# City of Sandy

### Planning Commission Meeting

**Meeting Date:** February 25, 2019  
**From** Emily Meharg, Associate Planner  
**SUBJECT:** Jacoby Heights Subdivision

All County Surveyors & Planners submitted an application on behalf of Cory Knight to subdivide 9.68 acres at 19124 Jacoby Road into a 32 lot subdivision. The 32 lots range in size from 7,500 square feet to 21,183 square feet. The subdivision proposal includes the extension of Newton Street into the site and three proposed local streets: Camden Court, Woodstock Street, and Middlebury Avenue. The applicant is requesting three (3) variances: a variance to Section 17.82.20 to allow future homes to not orient to Jacoby Road, a variance to Section 17.100.120(A) to allow a one-tiered lot configuration between Jacoby Road and Camden Court, and a variance to Section 17.100.120(B) to exceed a 400 foot block length on the north side of Woodstock Street between Camden Court and the east property line. In addition, the applicant is requesting a code interpretation related to the tree protection standards of Chapter 17.92, Landscaping and Screening General Standards – All Zones, and Chapter 17.102, Urban Forestry.

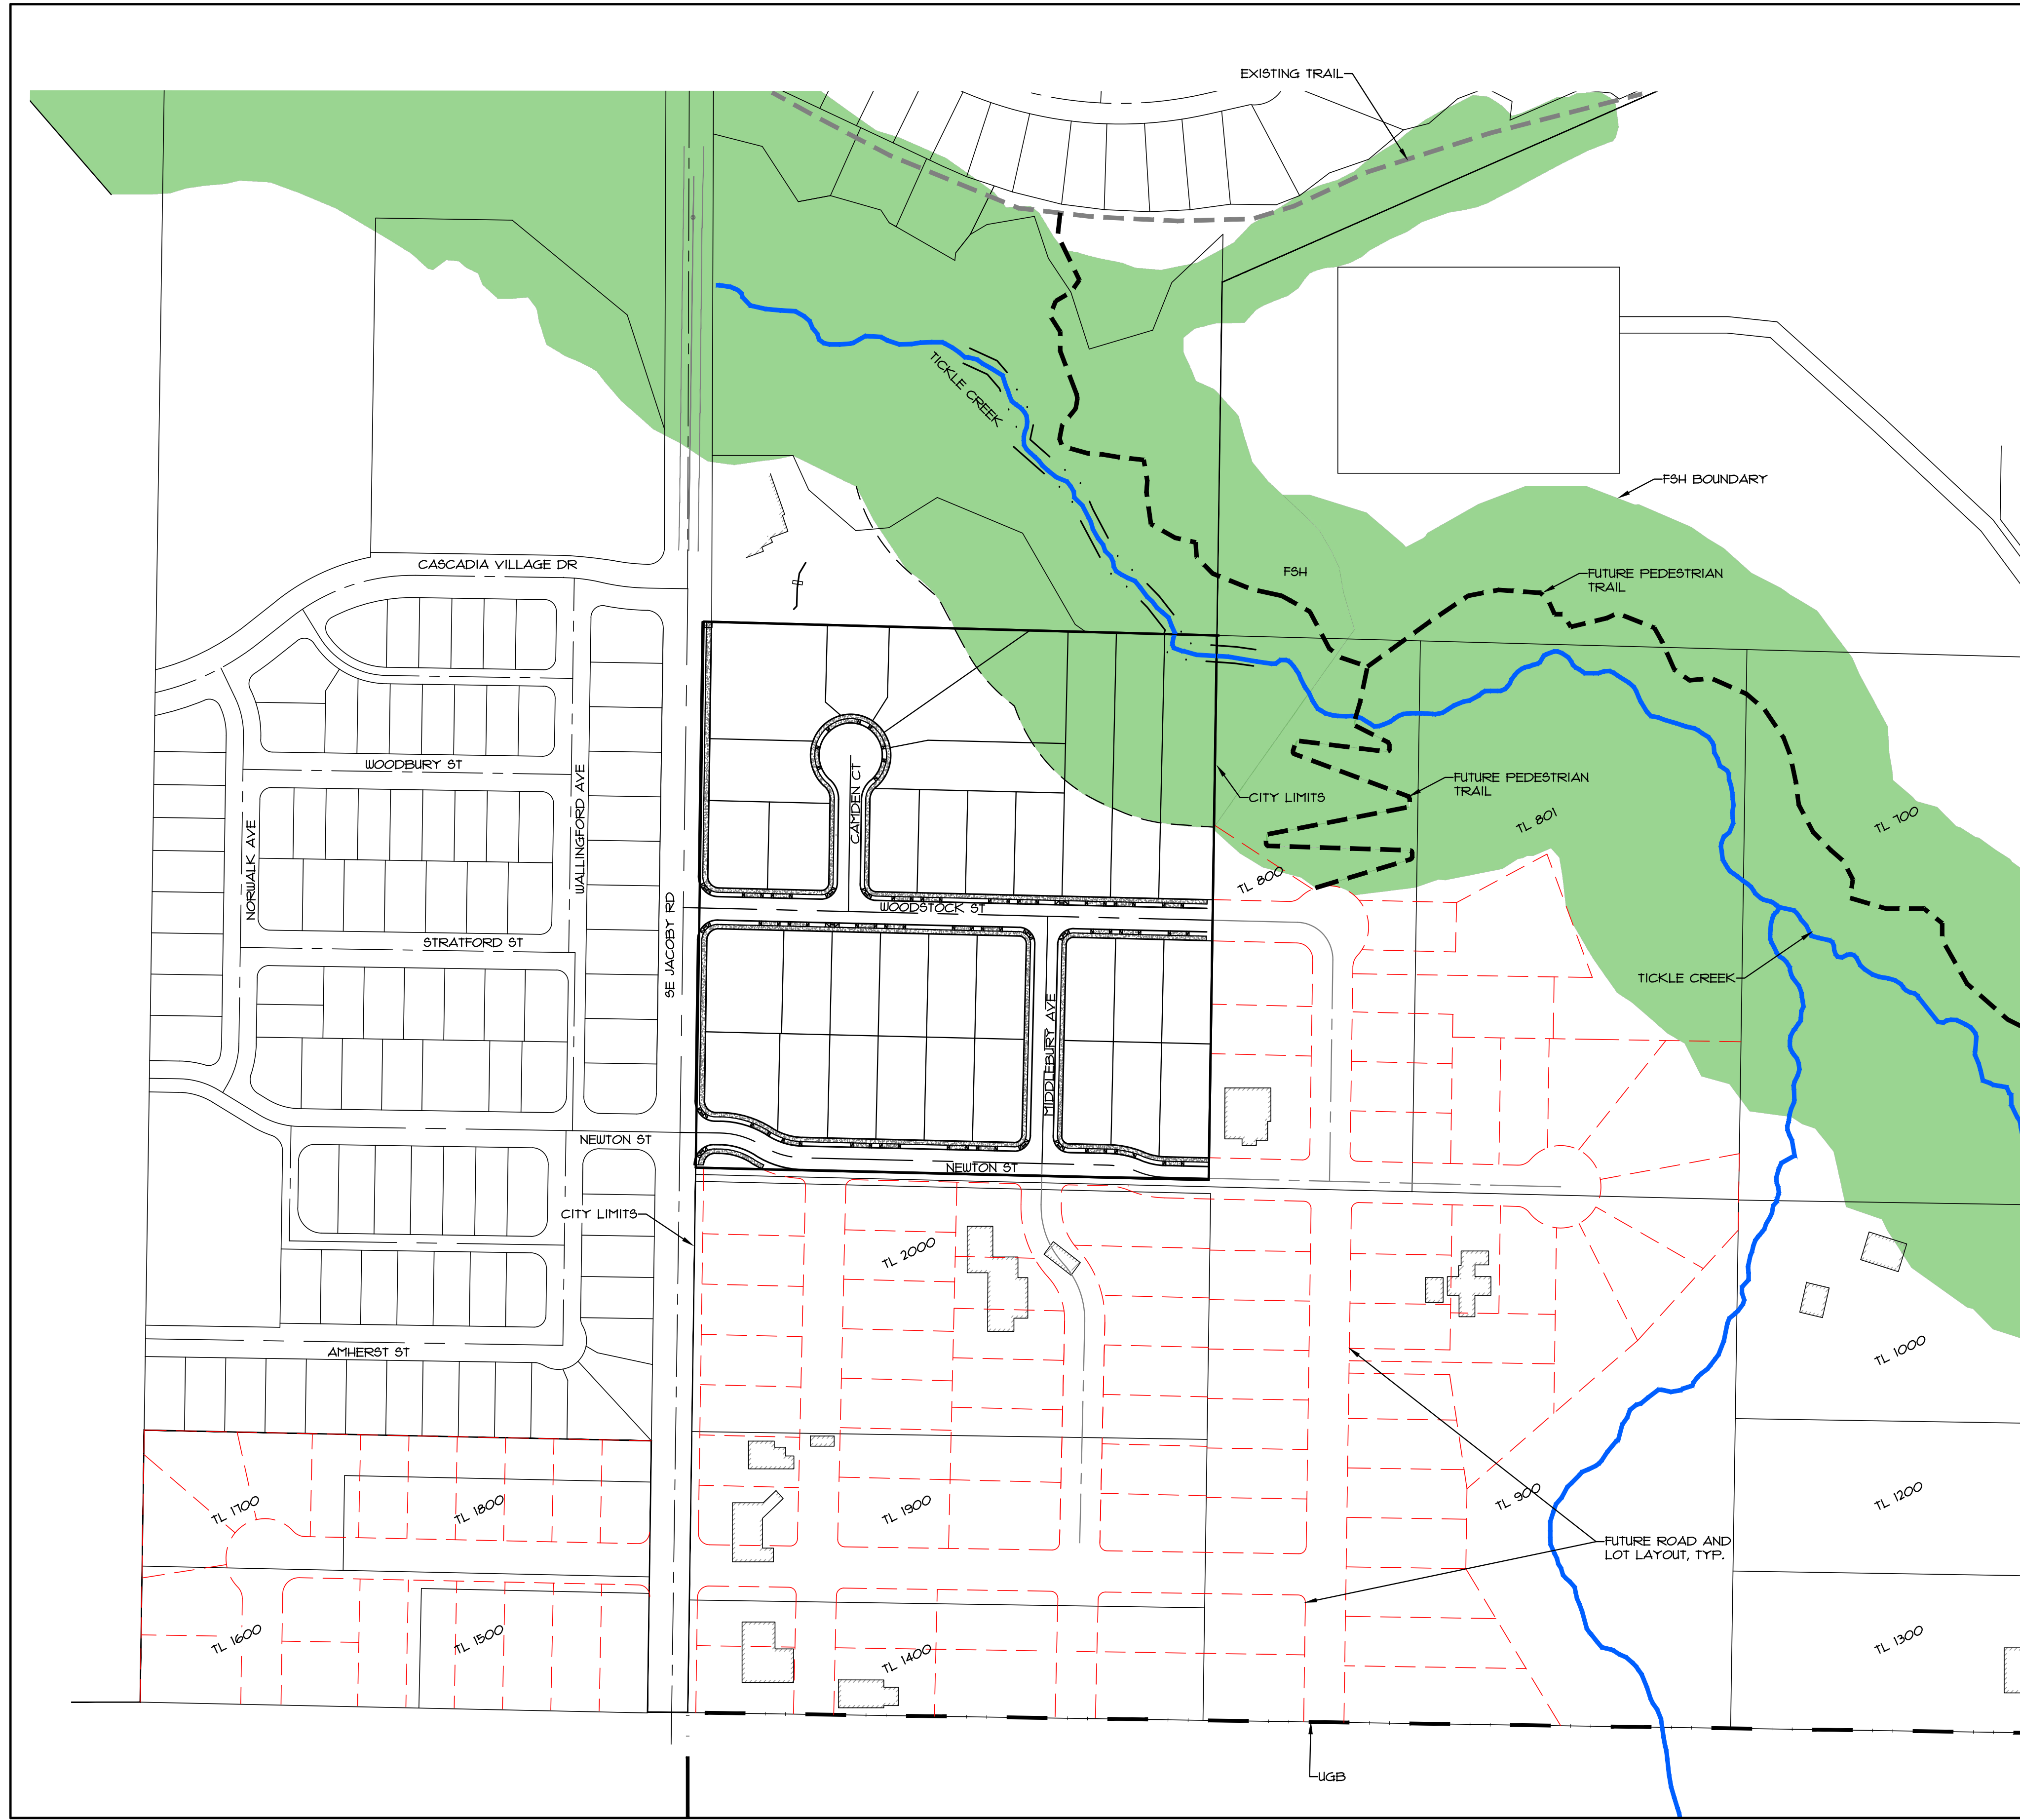
9. The developer's applicant has submitted a variance related to the 400-foot block length standard on Woodstock Street as required by Sandy Development Code (SDC), section 17.100.120(B). Sheet 8 of the preliminary plans provide a street layout and lots configuration on the adjoining properties, given the wetlands/Tickle Creek is located to the north, a stubbed street is not feasible. Extending the block length for approximately 100 feet appears to be reasonable and is compatible with the location of the existing house on the adjacent property to the east.
10. Half Street Improvements should be constructed along the entire site frontage with Jacoby Road to collector street standards to include curbs, sidewalks, street lights, landscaping strip with trees and utilities as appropriate. The improvements shall include an additional 10 feet of right-of-way dedications (60' ROW).
